UNITED STATES PATENT AND TRADEMARK OFFICE

Office Action Summary

09/892,790

DETAILED ACTION

FIG. 13b

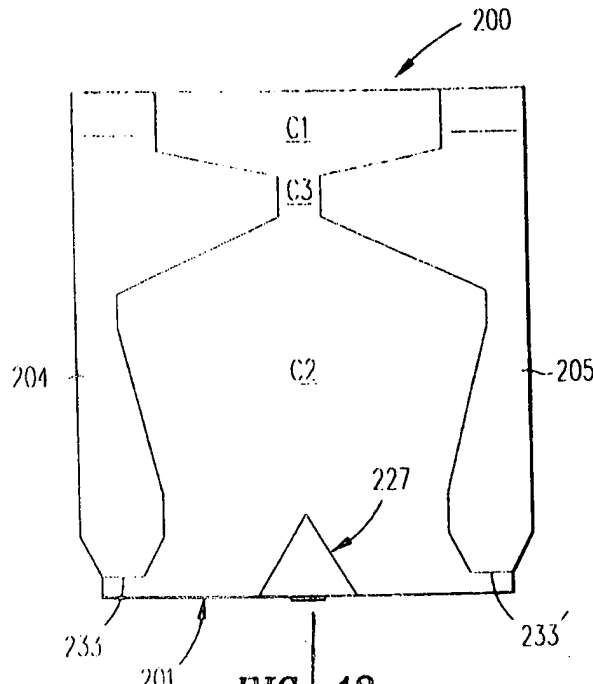
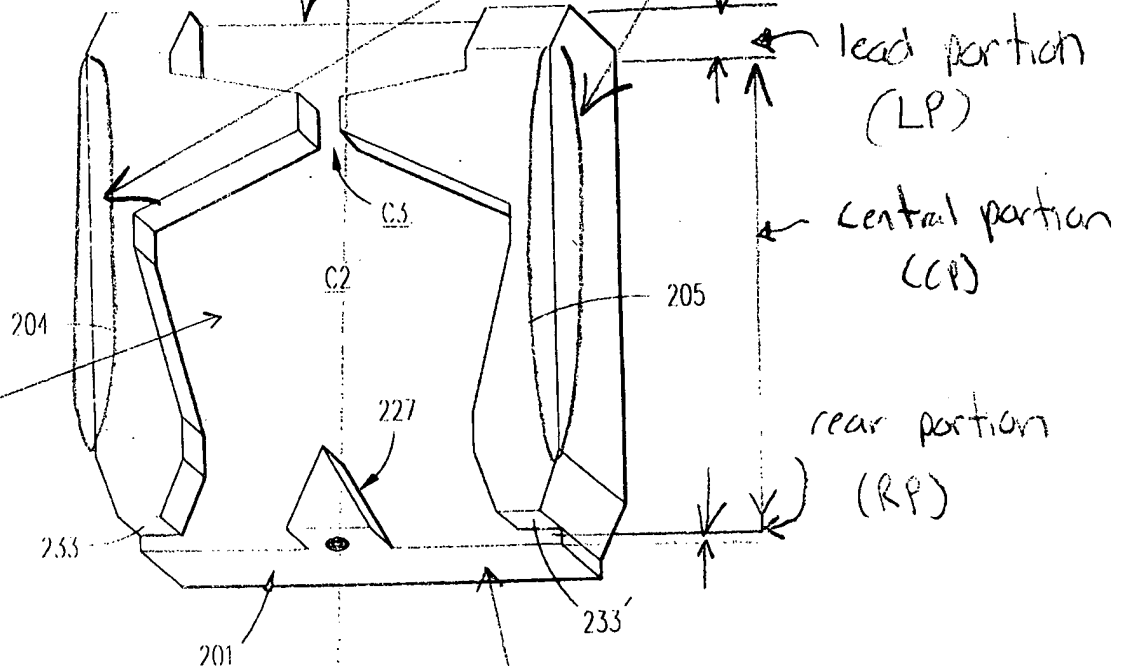
As per claim 21, Chhabra (US 5,831,791) discloses a negative pressure air bearing slider (e.g., 200 - see FIGS. 13a, 13b; see also appended Examiner's marked-up copy of FIG. 13b of Chhabra (US 5,831,791) at the end of this Office action) having a negative pressure cavity (C2),

As per claims 30, 41, 51, further comprising: a rear air bearing platform (227) accommodating mounting of a transducer (see FIG. 13b), said rear air bearing platform (227) being spaced downstream of said U-shaped air bearing platform (204, 205) relative to a rotational direction (RD) of said recording medium, and being centered with respect to a longitudinal axis (LA) of said slider body (200).

As per claim 32, wherein said U-shaped air bearing platform (204, 205) further comprises: a cross rail portion (portion of (204, 205) that extend toward each other as seen I FIGS. 13a, 13b) extending generally laterally across said principal surface (PS).

(RP) of said principal surface (PS) and respectively forming a first air bearing surface (surface of 204) terminating in a first side wall portion (e.g., side wall portion of (204) at end of (204) and contiguous with side edge of slider body as seen in FIGS. 13a, 13b)) and forming a second air bearing surface (surface of (205)) terminating in a second side wall portion (e.g., side wall portion of (205) at end of (205) and contiguous with side edge of slider body as seen in FIGS. 13a, 13b)), at least one of said not more than two separate air bearing platforms including a sidewall (e.g., another portion of the side wall portion of (204 or 205) at end of (204 or 205) and contiguous with side edge of slider body as seen in FIGS. 13a, 13b)) extending from one of said boundaries, with said U-shaped platform (204, 205) comprising an arcuately shaped front wall (portion of rails (204) and (205) which extend toward each other) oriented toward said lead portion (LP), at least one of said not more than two separate air bearing platforms (204, 205) extending from an edge (side edge of slider body) of one of said boundaries.
